08 - 2010
BBX7600 / BBX7600CA
76CC BLOWER

SERVICE CHANGES

1. Changes on Engine Cover

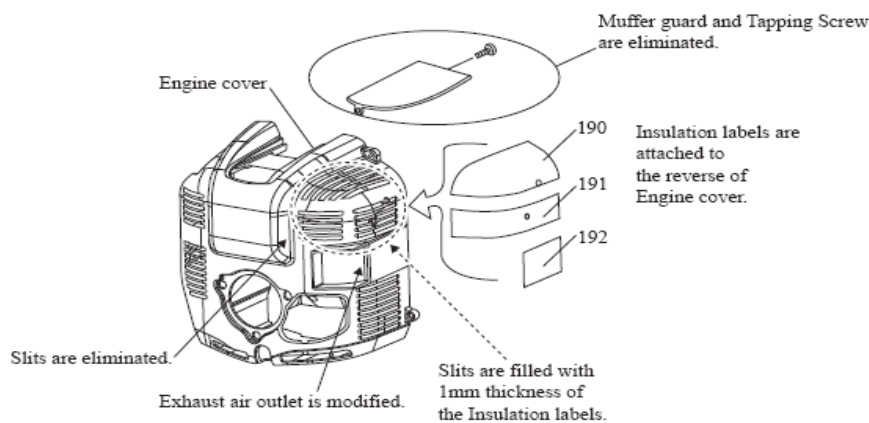
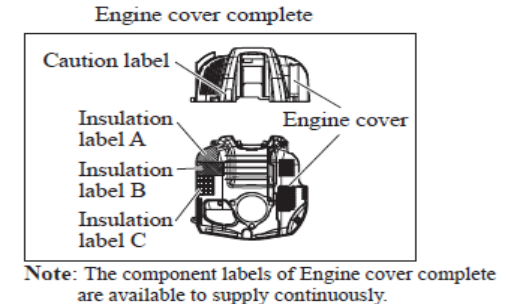
Item No.	Description	(T/I# Y05064)		(T/I#Y05801)	(T/I# Y06063)	(T/I# Y06152)	(T/I# 97294)
		Type 1	Type 2	Type 3	Type 4	Type 5	Type 6
30	Engine Cover	6676500802	6676500803	6676500804	6676500805	453712-8	141521-4 (INC. Item 25, 190-192)
24	Muffler Guard	6676500700			----		
23	Tapping Screw 4x6	0150049820			-----		
190	Insulation label A	----		6676501500 OR 443174-8			
191	Insulation label B	----		6676501600 OR 443175-6			
192	Insulation label C	----		6676501700 OR 443176-4

Exit for gas emission

Exit for gas emission has been modified

Above parts are completely interchangeable as a set.

2. Screw Assy and Socke Head Bolt

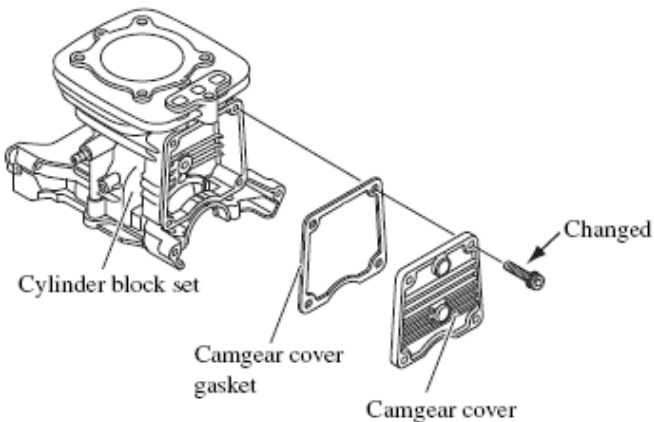
Item No.	Description	Type 1	Type 2	Type 3
72	Screw Assy/ S.H.Bolt	004-36051-60	0119059531	266813-1

*Above parts are interchangeable each other.

3. Changes on Screw and Screw Assy

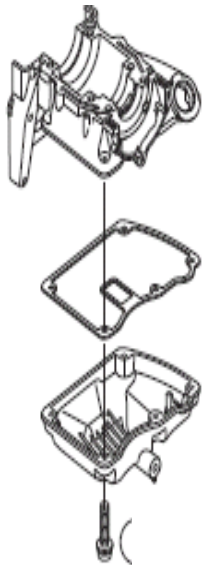
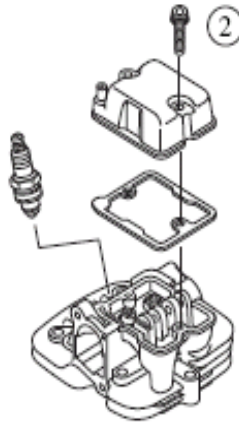
Item No.	Description	Type 1	Type 2	Type 3
82	Screw M5x25	0140059680		0119059390
60	Screw Assy	0043605300	0119059570	266789-2

M5x25 Screw with flat washer and spring washer for Oil case

M5x25 Socket head bolt with flat washer and spring washer for Oil case

Screw ass'y with flat washer and spring washer for Rocker cover

M5x30 S.H.Bolt with flat washer and spring washer for Rocker cover

Above parts are interchangeable each other. (Type1 remains available)

4. Cam Lifter

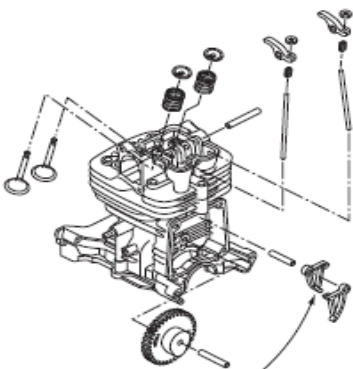
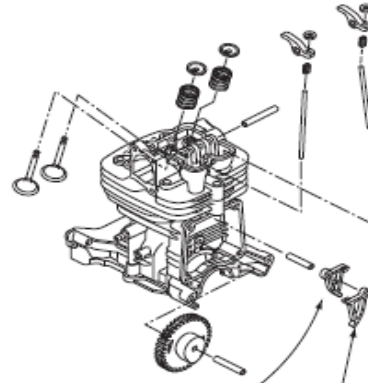
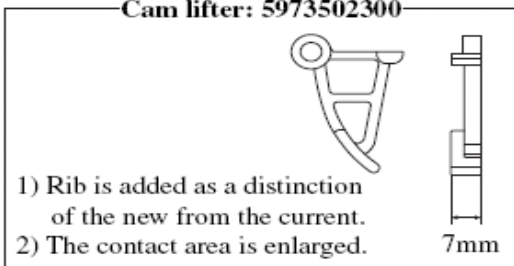
Item No.	Description	Type 1	Type 2	Type 3
102	Cam Lifter	5973500601 (2PC)	5973500601 (1PC)	313266-6 (1PC)
187	Cam Lifter	-----	5973502300

Both exhaust and intake sides
Cam lifters : 5973500601

Exhaust side
Cam lifter: 5973502300

Intake side (The cam lifter remains 5973500601.)

- 1) Rib is added as a distinction of the new from the current.
- 2) The contact area is enlarged.

Above parts are completely interchangeable as a set.

5. Screw, Screw Assy, Socket Head Bolt

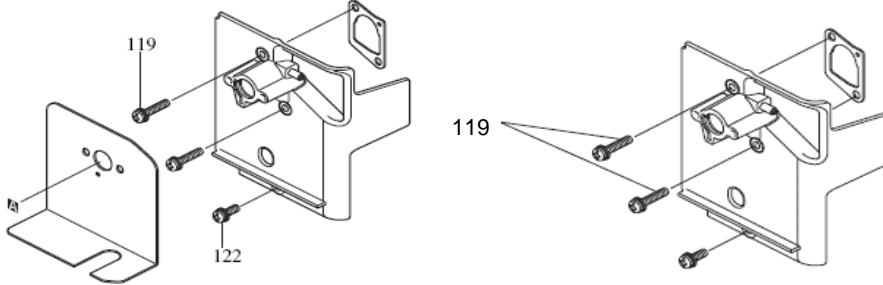
Item No.	Description	Type 1	Type 2	Type 3	Type 4
119	Screw M5x25 / S.H.Bolt M5x25	0140059680	119059390 (Do Not Use)	0119059640 (S.H.Bolt)	266749-4
122	Screw Assy M5x14	0043605140	0119059490 (S.H.Bolt M5x14 W,SW)

Above parts are completely interchangeable as a set.

6. Air Case Cleaner Assy and Separator Plate

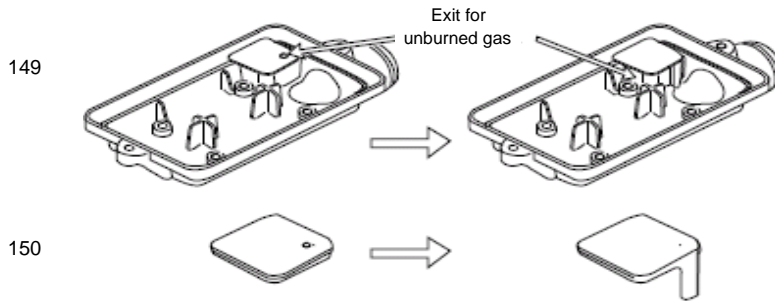
Item No.	Description	Type 1	Type 2
149	Air Case Cleaner	6676003001 (N/L/A)	6676003002
150	Separator Plate	6676500600 (N/L/A)	6676501300

7. Addition of Fan Cover and Rock Rivet to Frame complete

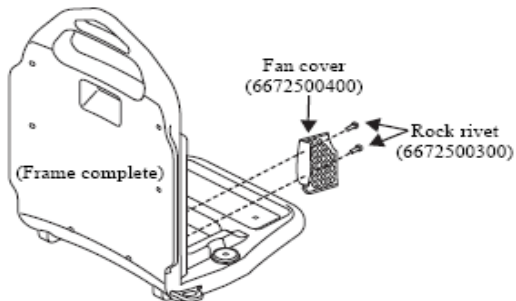
Item No.	Description	Type 1	Type 2
188	Fan cover	-----	6672500400
189	Rock rivet	-----	6672500300

9. Changes around Valve

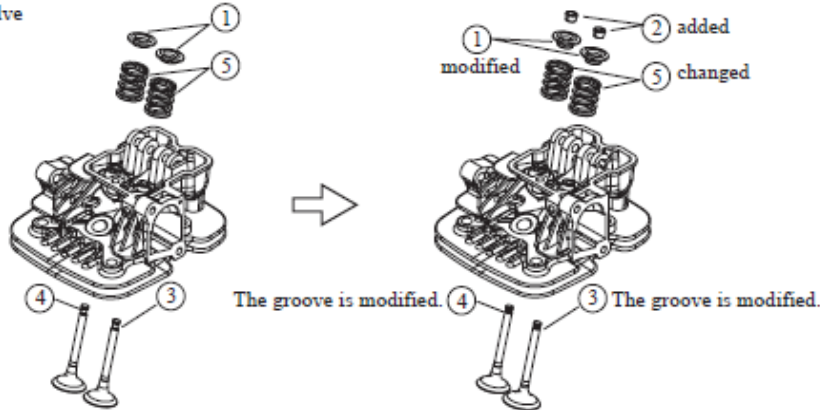
Item No.	Description	Type 1	Type 2	Type 3	Type 4	Image No.
94	Intake valve		5973500100		331964-0	3
95	Exhaust valve	5973500200	5973500201	5973500202	331965-8	4
96	Spring		5973500301		234212-5	5
97	Retainer		5973500400		331966-6	1
198	COTTER		----		331967-4	2

Exhaust side ... Item No. 95, 96, 97 and 198 are interchangeable as a set.

Inner take side ... Item No. 94, 96, 97 and 198 are interchangeable as a set.

10. Changes around Cylinder Head

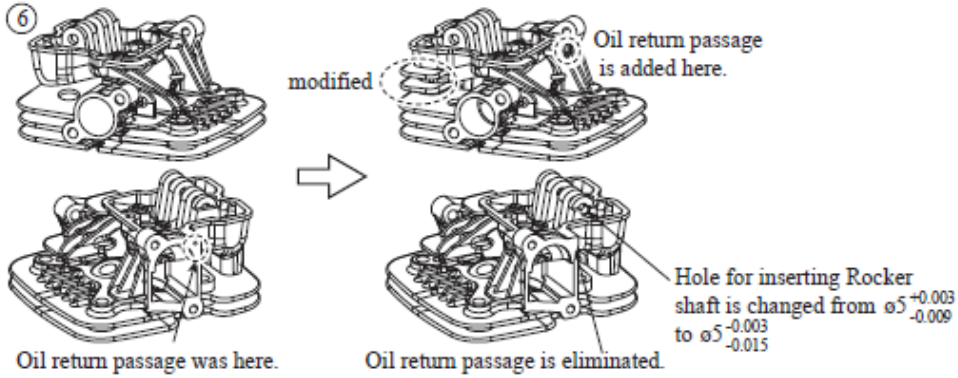
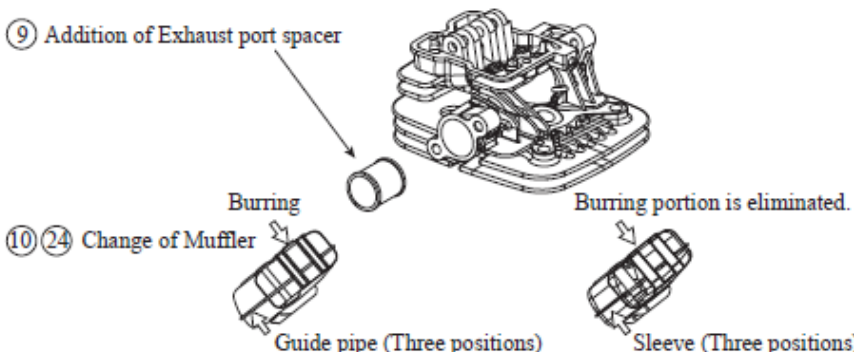
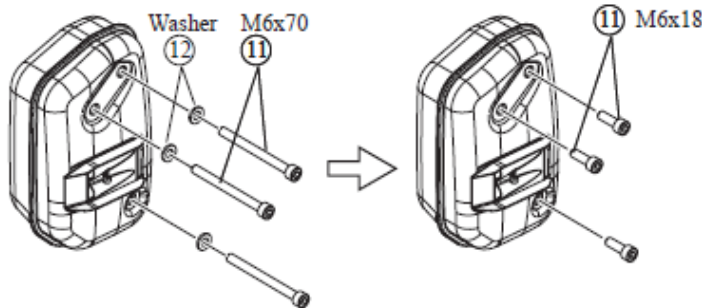
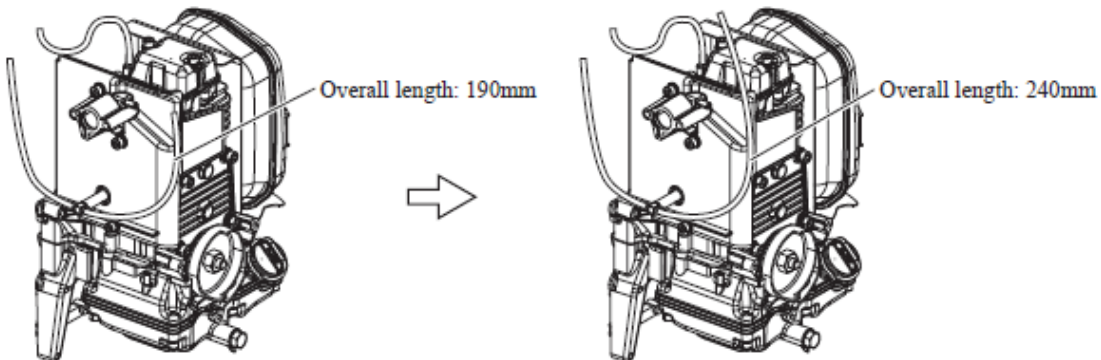
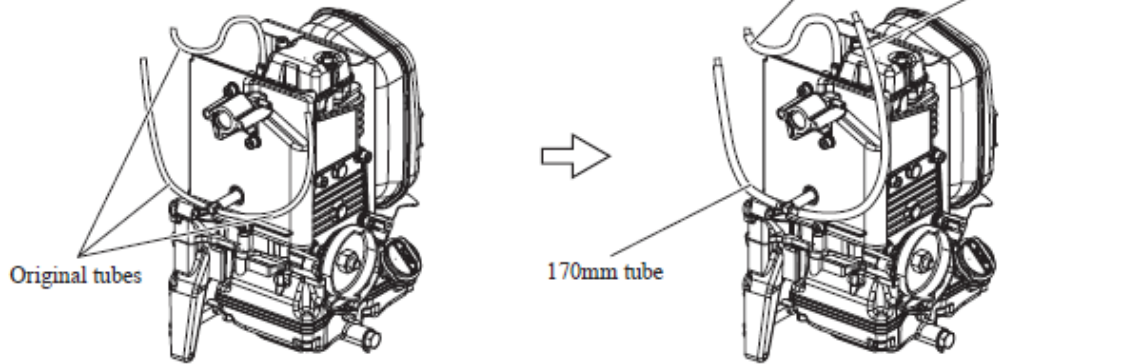
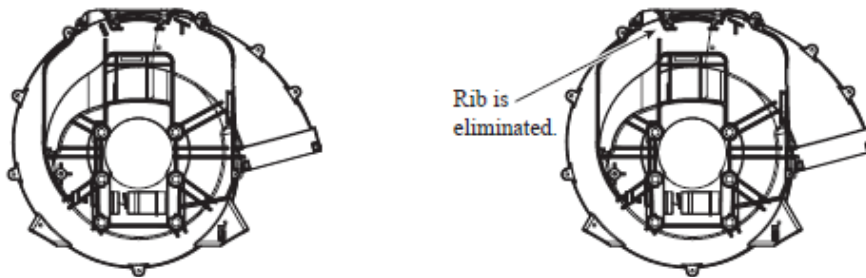
Item No.	Description	Type 1	Type 2	Type 3	Type 4	Image No.
19	Case 2 Volute Assy	6671008001		671008002	6671008003	18
63	Cylinder head com.	5971003001		5971003002 (INC. Item No. 98 & 99)		6
98	Shaft	5973500500		5973500501		7
99	Rocker arm assy	5973004000	126005-3	126005-3		8
199	Exhaust port spacer	----	331937-3	331937-3		9
169	Exhaust muffler	5973001001	5973001002	5973001003		10
170	Washer	0200069890		----		12
171	S.H. Bolt	0119069650		266771-1		11
158	Tube 3-190	0851199960 (2 pc.)		0851199960 (1 pc.)		13-1
200	Tube 10-100/10-50	----		412123-6 (110mm)	412130-9 (50mm)	14
201	Tube 10-170	----		412127-8		15
202	Tube 10-220	----		412124-4		16
203	Tube 3-240	----		412122-8		13-2
61	Rocker Cover	5971500700		5971500701	141771-1	22
154	Tube 3-130/3-105	0851139920		412121-0 (130mm)	412129-4 (105mm)	24
155	Hose Clamp	0561079990			282027-4 or 0561069990

⑦ Change of Outer diameter of Rocker arm shaft $\phi 5^{0}_{-0.010} \rightarrow \phi 5^{0}_{-0.002}$

⑧ Rocker arm assembly is treated as the component of ⑥. However, the current parts remain available.

⑨ Addition of Exhaust port spacer

⑩⑭ Change of Muffler

⑪⑫ Change of Bolt for securing Muffler

⑬-1 ⑬-2 Change of Tube (one of Two tubes is changed.)

⑭⑮⑯ Addition of Tubes to protect the original tubes

Three tubes are added on the original tubes.

⑰⑱ Change of Case 2 volute assy

⑳ Change of Rocker cover

Type 2 & Type 3 parts are completely interchangeable as a set.

Type 3 & Type 4 parts for Item 61, 154, 155 and 200 are interchangeable as a set.

11. Available Anti-Static Belt Set as optional Accessory

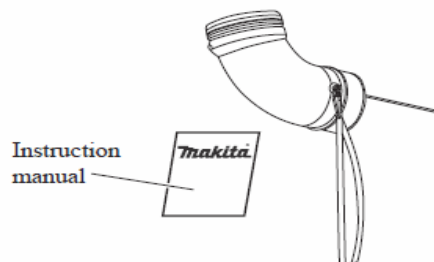
Item No.	Description	Type 1
A10	Anti-Static Belt Set	196334-8
